Report to the Future Melbourne (Planning) Committee

**Ministerial Planning Referral: TPMR-2019-1
423 Bourke Street, 140 Queen Street, 150 Queen Street and 21-27 McKillop Street, Melbourne**

15 October 2019

DELEGATE REPORT MINISTERIAL PLANNING REFERRAL

REVISED COMPLIANT SCHEME (SEP 2019)

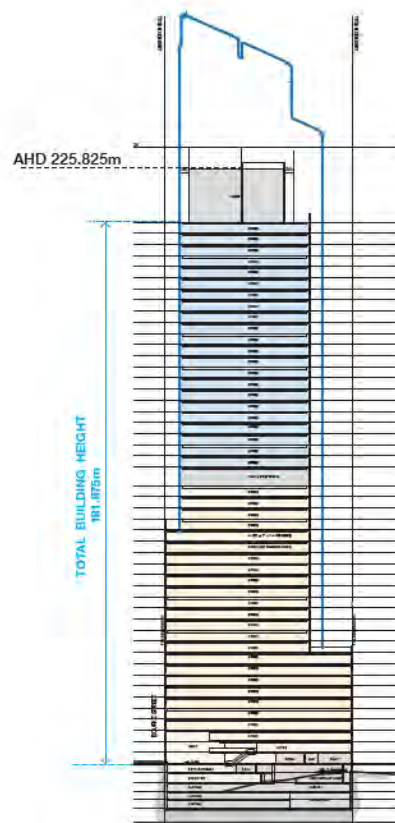
Following feedback received from the Minister for Planning on 8 September 2019 and subsequent discussions between the applicant and DELWP (9 September 2019) and City of Melbourne officers (10 September 2019) the application was formally amended on 19 September 2019 under Section 50 of the *Planning and Environment Act 1987*.

The changes involved a modified built form that conforms with all objectives and requirements of DDO10.

Modified concept western façade of 140 Queen Street (Bate Smart September 2019)

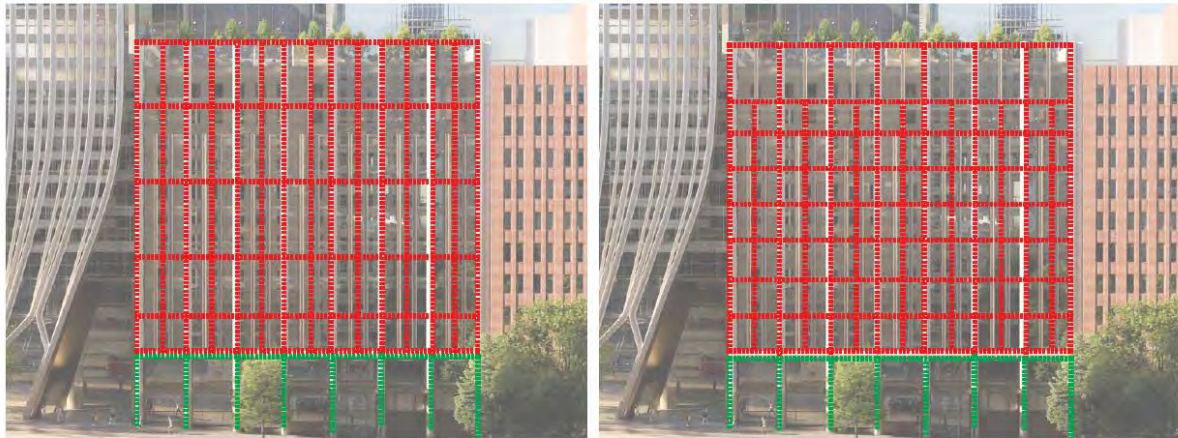
- *The applicants have responded positively to most of our comments. Agree that many of the previous comments relating to design detail, which were not directly addressed in this package, could be addressed via Permit Conditions. Key conditions include:*
 - *Ground floor layout, connectivity, and maximise building entries*

- *There is a high degree of integration and detail resolution of the canopy within the openings of the ornamental stone / grc columns. The additional steel mullions between the openings further breaks down the rhythm of the ground floor and contributes to a tactile human-scale experience.*

- *Support the extent of stone treatment to match the canopy height and agree that this is the natural point of material transition.*
 - *The preliminary stone profile detail which depicts a fully integrated glazing system with no visible gaps between the cladding and glazing line is supported. Recommend a permit condition to safeguard this design intent through delivery.*

Queen and Bourke Street elevation (Bate Smart September 2019)

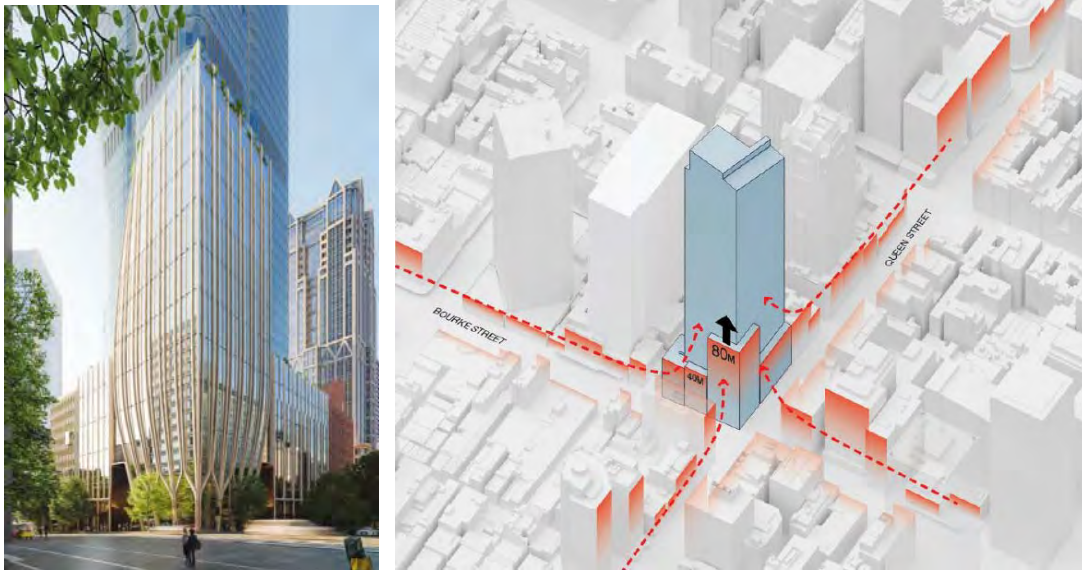
- *The Bourke Street podium façade appears to show additional steel plate mullions within the stone cladded grid which is supported especially on the lower levels of the façade (shopfront), where the additional filigree and tactility will have a positive impact to the pedestrian environment.*

The approach to the design of the canopy which strongly relates to the width and rhythm of the openings / bays within the ground floor façade design is supported. The revised July 2019 plans show canopies constructed from laminated glass and steel along both Bourke and Queen Streets. The footpath clearance of these canopies have been reduced to achieve a human scale response and to also provide better weather protection. The weather protection elements are supported.

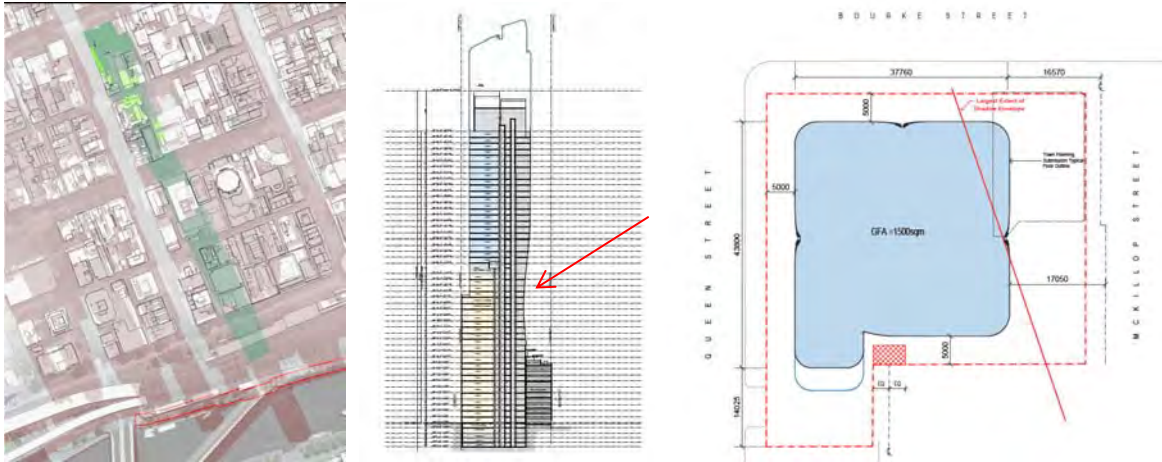
The wind conditions for the Proposed Configuration in the streetscapes that surround the 435 Bourke Street development satisfy the safety criterion.

The wind assessment has demonstrated compliance with the wind requirements of DDO10 and is supported.

2pm June 22 additional shadows (green); Section of the building showing the area carved out to reduce shadow impacts on McKillop Street and Proposed typical tower floorplate showing maximum amount of area lost for shadowing (Bate Smart September 2019)

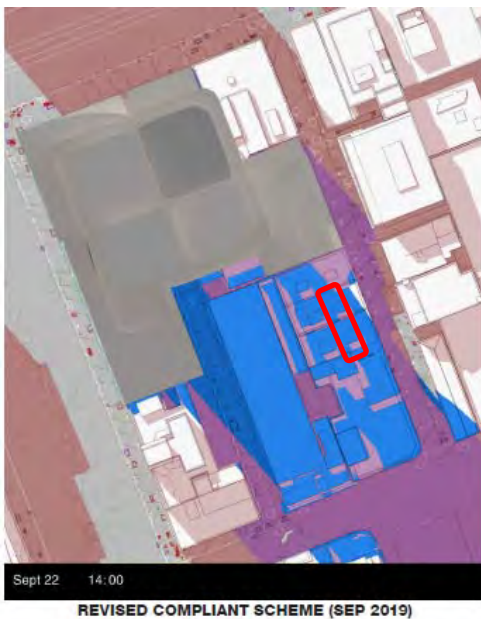
DDO10 states the following in regard to a discretionary overshadowing provision:

- No overshadowing of McKillop Street and privately owned public spaces accessible to the public between 11am and 2pm, between 22 April and on 22 September, unless the overshadowing will not unreasonably prejudice the amenity of the space.

On balance with the proposed tower adjusting its form to reduce the shadow impact on McKillop Street and the fact that only a minor amount of area is overshadowed for four days of the year, these in minor incursions are considered not have a significant impact on the attractiveness and use of McKillop Street.
